MEMORANDUM

From: Sustainable Transport
Date: 15 July 2026

PL/2025/01555 - Land at Blackmore Farm, Sandridge Common, Melksham, SN12 7QS - A reserved matters application (appearance, layout, scale and landscaping) for 229 dwellings and associated infrastructure – Reserved Matters pursuant to Outline permission PL/2023/11188

Figure 2.2 – Access and Movement Strategy – Potential Internal bus rote, Transport Update Note 8 August 2024

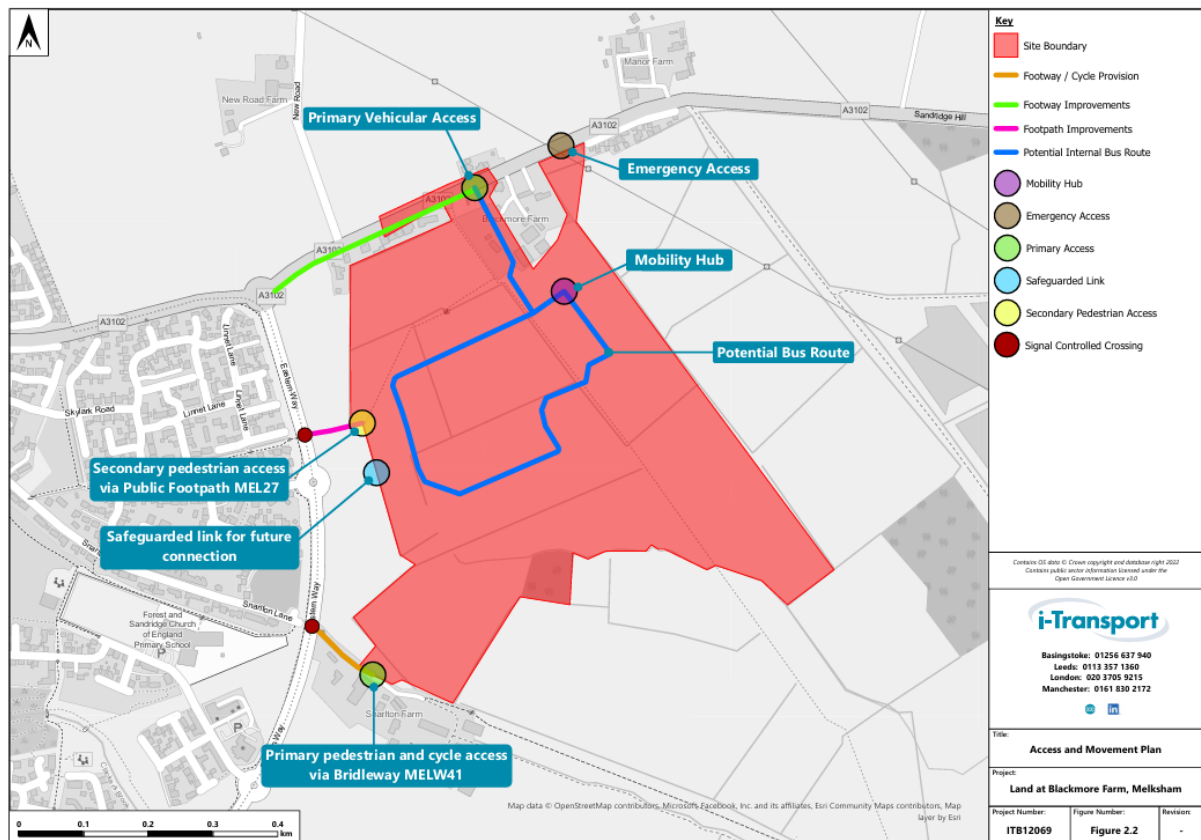
It is clear from the Transport Update Note detailed below that the intention is to have a bus loop.

I would suggest that 6.5m bus route is provided along this basis. I note that part of this loop is not part of this planning application. Instead of demanding a 6.5m route through a typical 5.5m Mfs residential street to the north, I would suggest, that where this loop can not be provided at this stage, that a temporary route / loop is provided. Or the planning application is amended accordingly to provide this route. Please update.

With regard to Figure 2.2 of the transport update note (detailed below) it would appear a large extent of this bus route is already on the primary route.
